ADDENDUM No. 1

ITB No. 4544

Riverside Park Boardwalk Replacement

EXISTING CONCRETE APPROACH DETAIL
SCALE: 1/2" = 1'-0"
TO APPLY: STA 13+83 (POE)

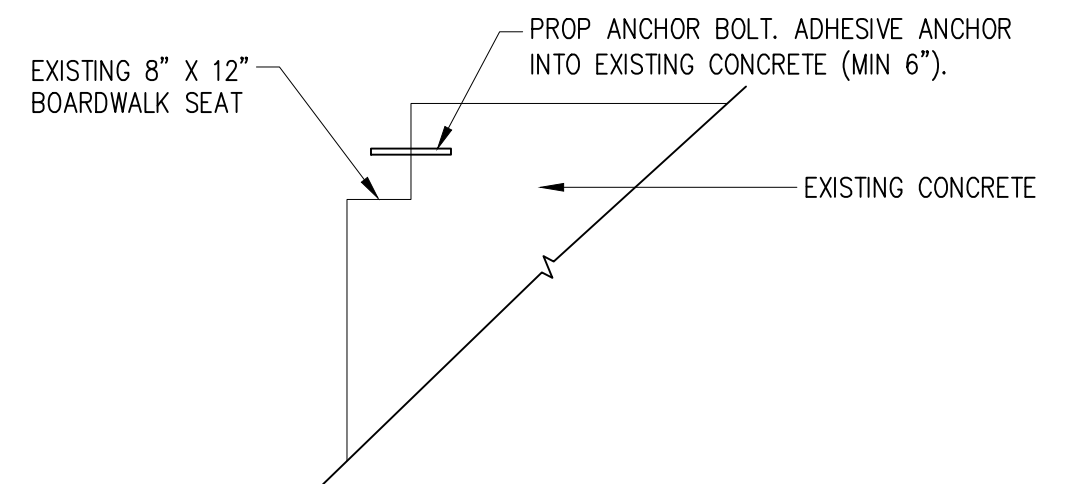
Answer 7: Refer to the MDOT 2012 Standard Specifications for Measurement and Payment. The structural steel pay item is for the boardwalk support bracket (Sheet 5, Boardwalk Support Detail and Bracket). The Adhesive Anchoring pay item is intended for the anchoring of the anchor bolts to the existing concrete approach at the POE (Sheet 4, Existing Concrete Approach Detail).

BOARDWALK RAILING ELEVATION
SCALE: 1/2" = 1'-0"

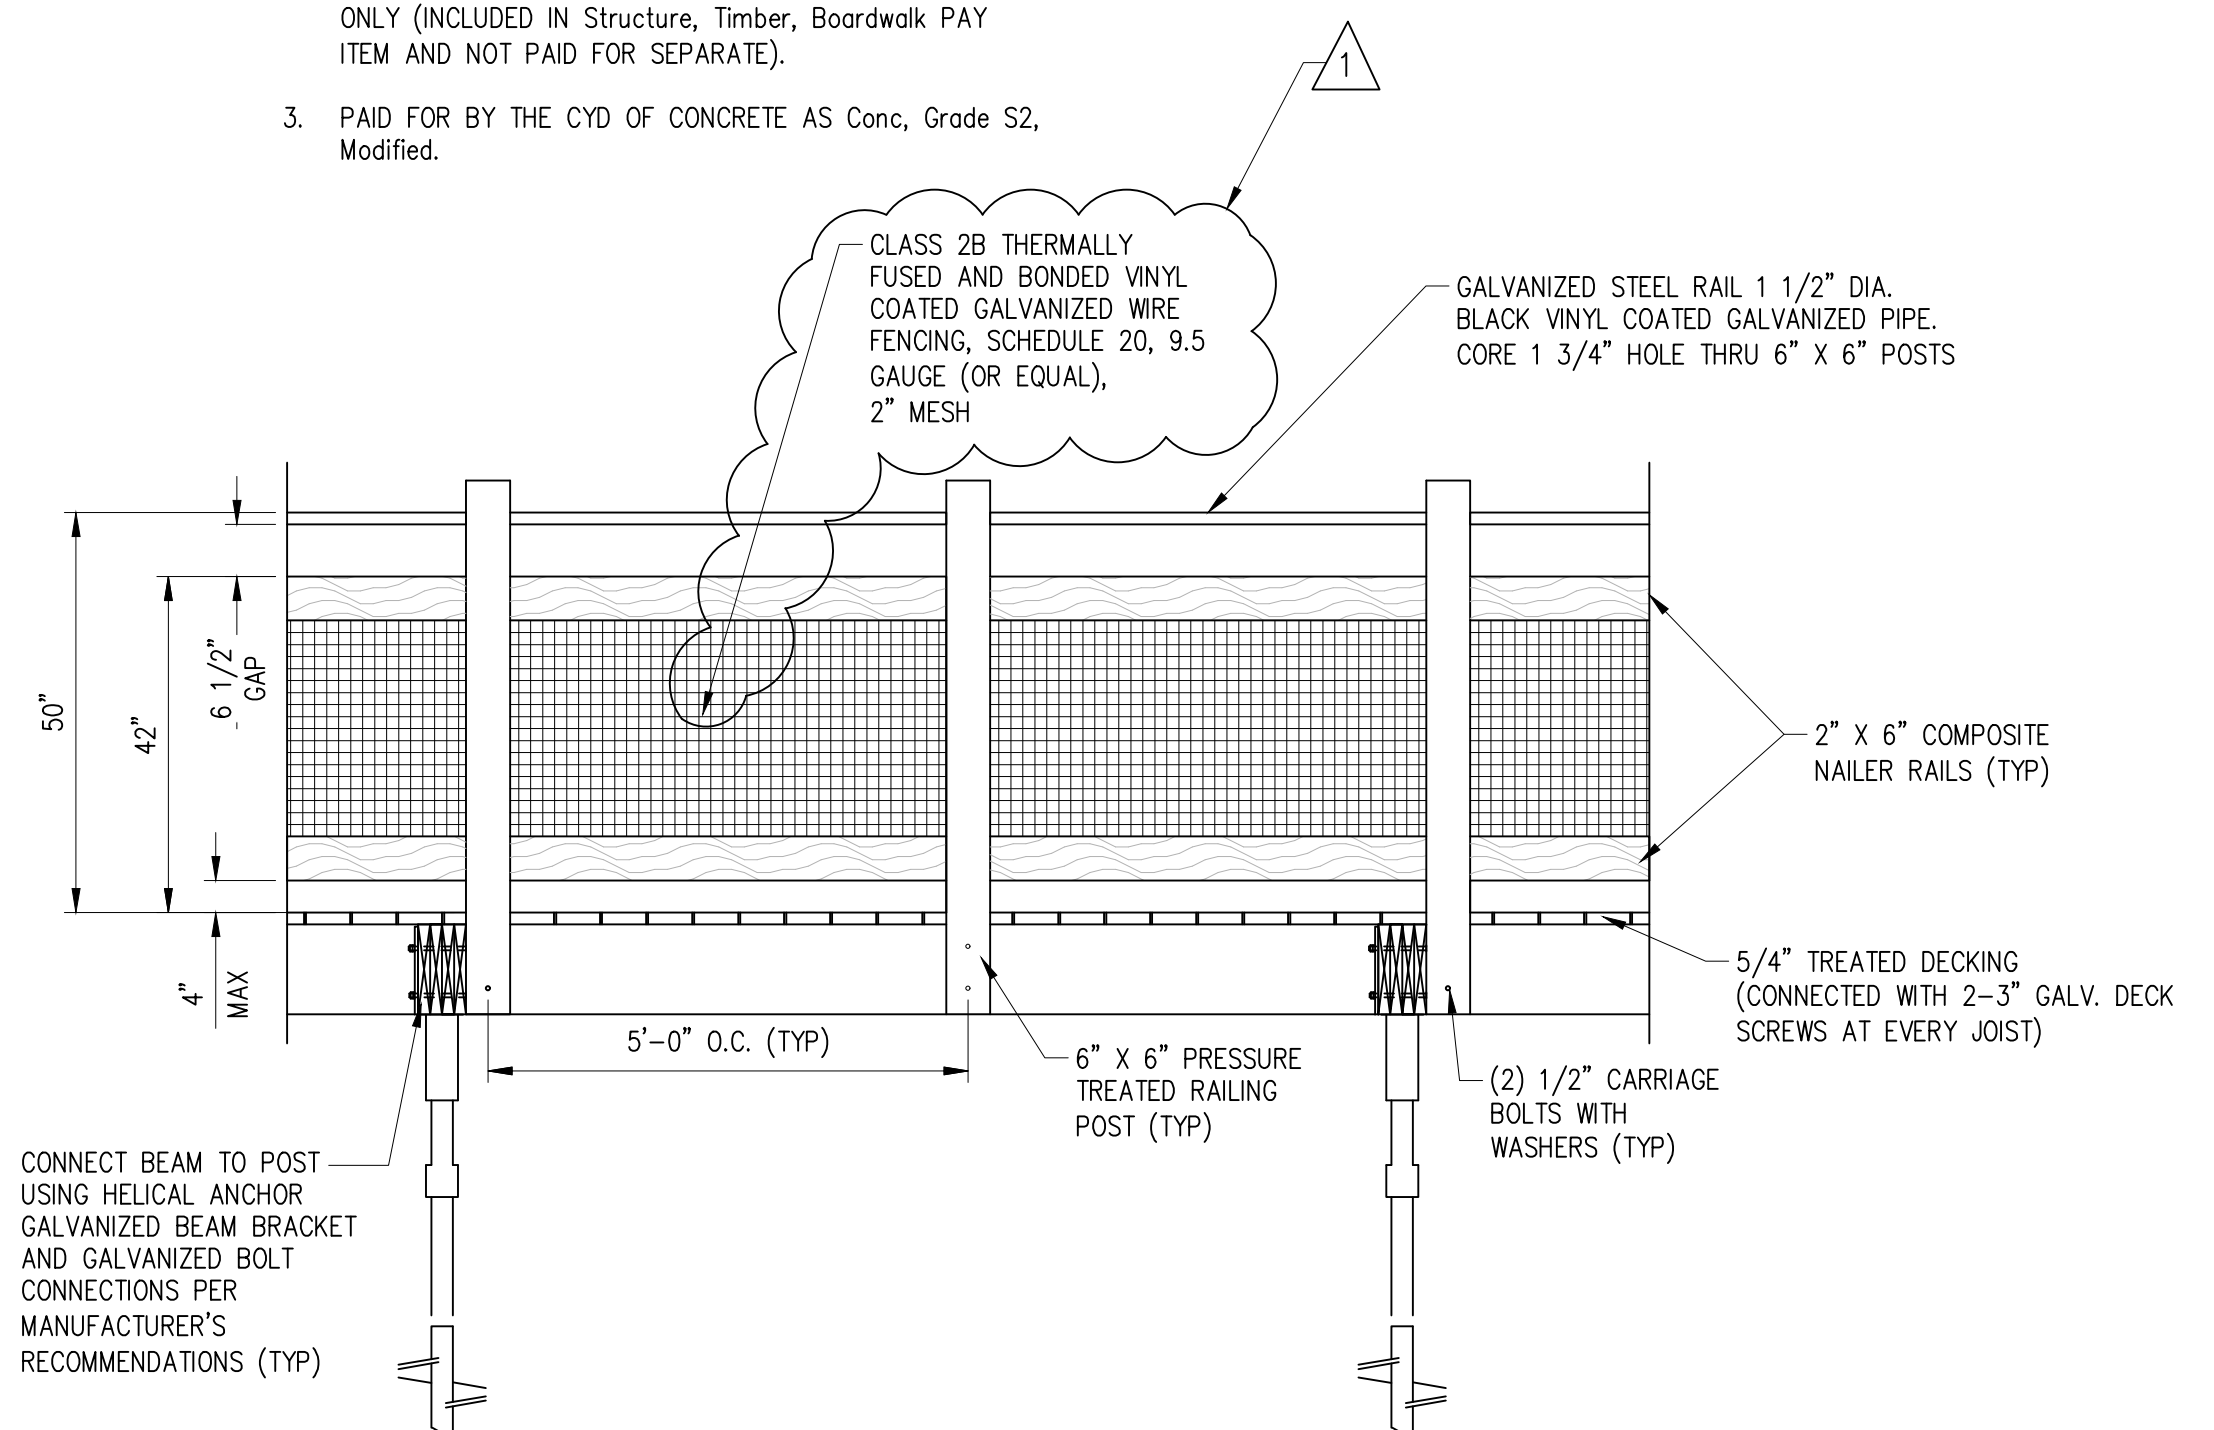
Section/Page(s)	Change
Drawing 4	Updated the wire mesh specifications on the Boardwalk Railing Elevation.
Drawing 7	Updated to reflect revised site access.
